RE: Puget Sound Nutrient General Permit (PSNGP) Preliminary Draft Comments

General Comments on Puget Sound Nutrient General Permit

Specific Questions from Ecology

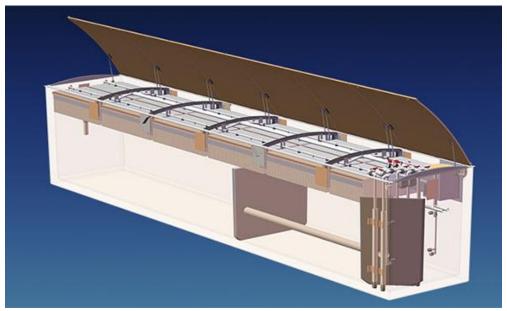
- 5. Do reviewers have suggestions for "reasonable investments" at small (<3 MGD), medium (3-10 MGD) and large (>10 MGD) that could be used to separate the two tiers of optimization actions required by this permit? Two items: 1) a full educational campaign that makes all aware that every drop of water they use will eventually end up in the Puget Sound and affect our water quality and all that live in that environment. With stickers at every water source and products that are used with water, thus ending at the WWTP. 2) Another would be the installation of a living system.

https://twitter.com/suez/status/976819715984318464/photo/1 These could be as large or small as space allows.
